**BOARD OF COUNTY COMMISSIONERS  
ORANGE COUNTY, FLORIDA**

**ADDENDUM NO. 3 / IFB NO. Y18-729-TA**

**SOUTH WATER RECLAMATION FACILITY INFLUENT PUMP STATION  
IMPROVEMENTS**

SCALE: NOTED  
DRAWING NO.:  
S18  
SHEET: 58 OF 123

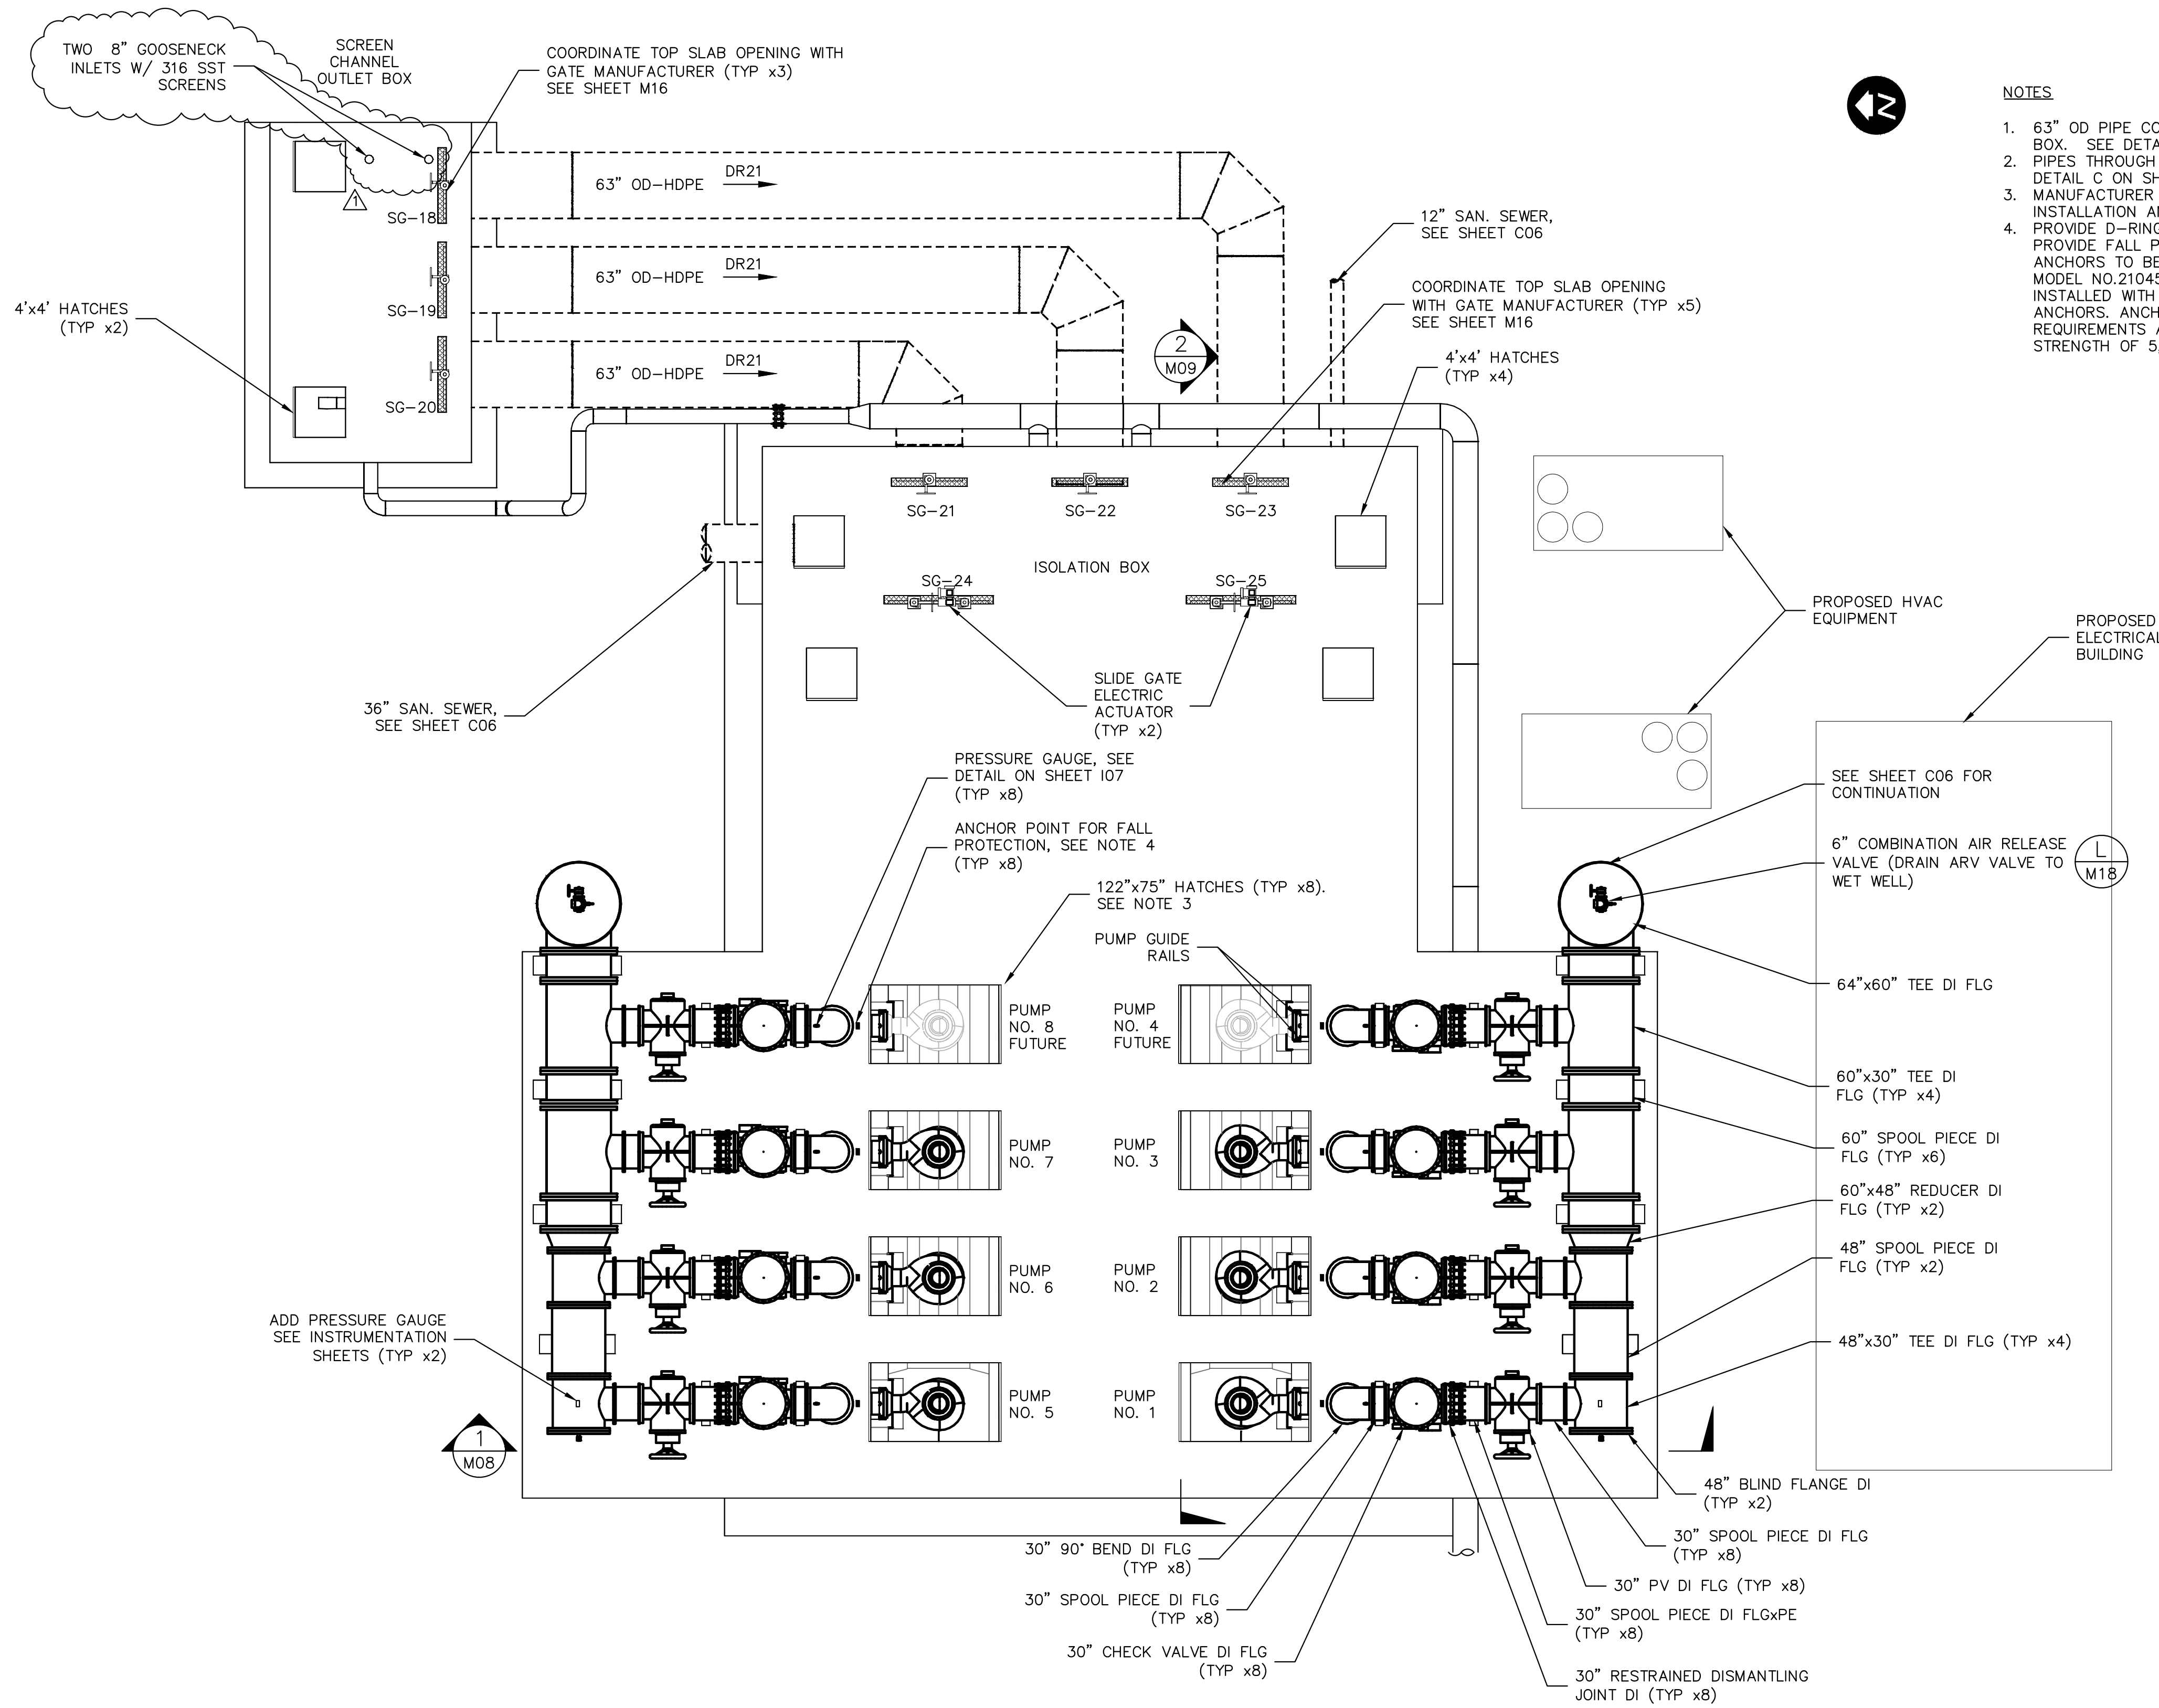
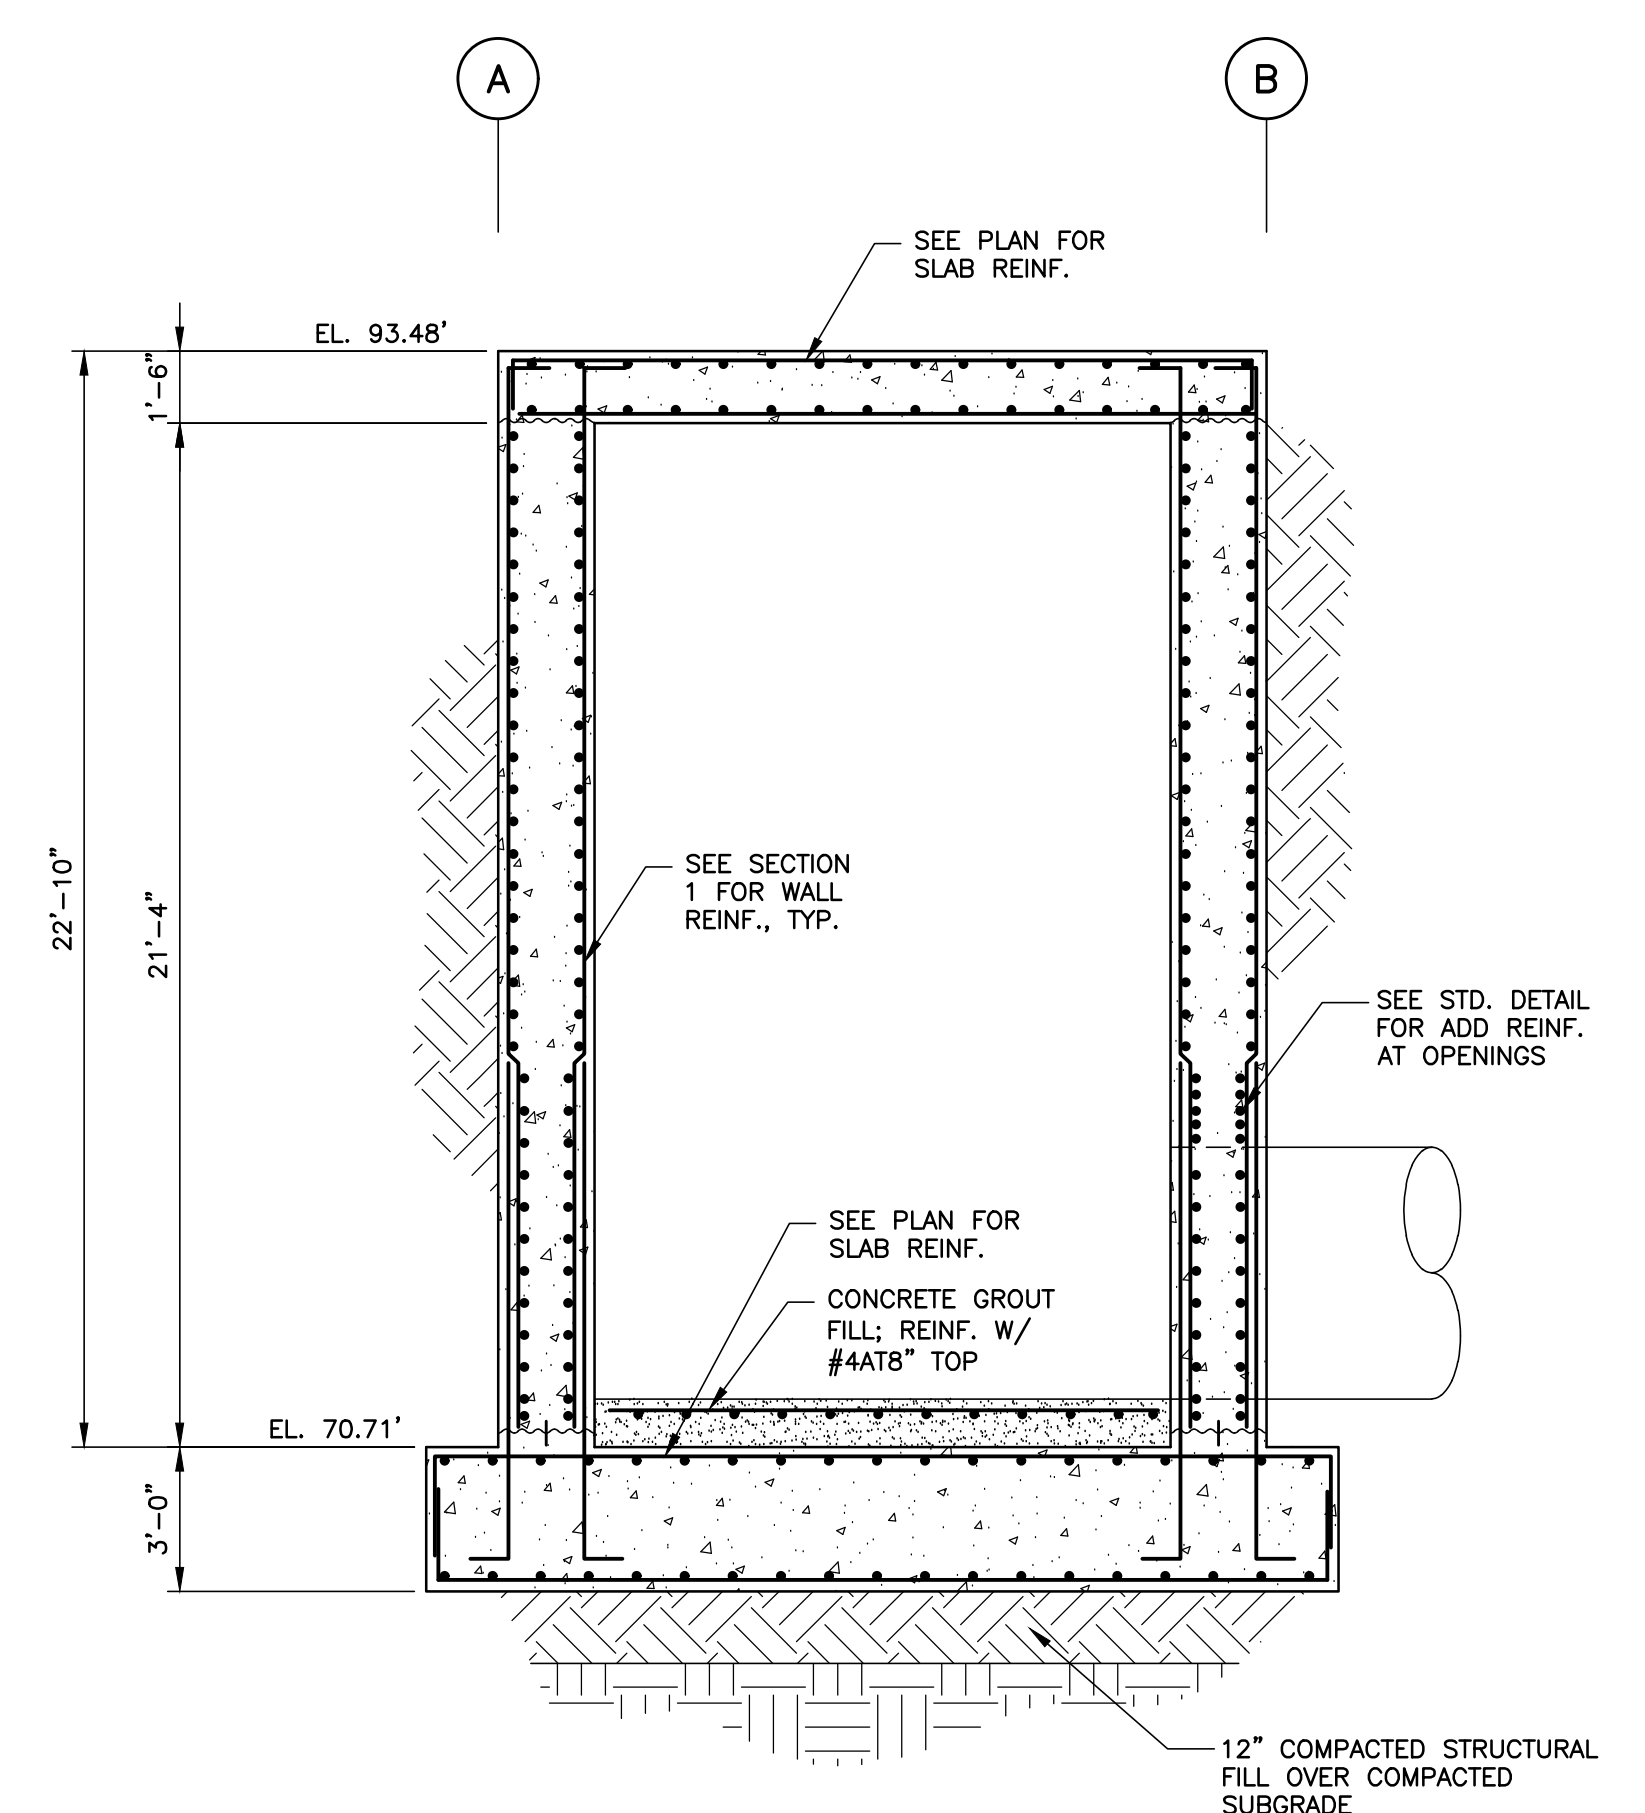
4. Drawing S18 be deleted in its entirety and replaced with the attached Revised S18 drawing.
5. Drawing M06 – Delete note 2 in its entirety and replace with “2. PIPES THROUGH CONCRETE WALLS PER PIPE PENETRATION DETAIL C ON SHEET M-17.”
6. Drawing M07 to be deleted in its entirety and replaced with the attached Revised M07 drawing.
7. Drawing M08 to be deleted in its entirety and replaced with the attached Revised M08 drawing.
8. Drawing M09 be deleted in its entirety and replaced with the attached Revised M09 drawing.
9. Drawing M15 be deleted in its entirety and replaced with the attached Revised M15 drawing.
10. Drawing M16 to be deleted in its entirety and replaced with the attached Revised M16 drawing.
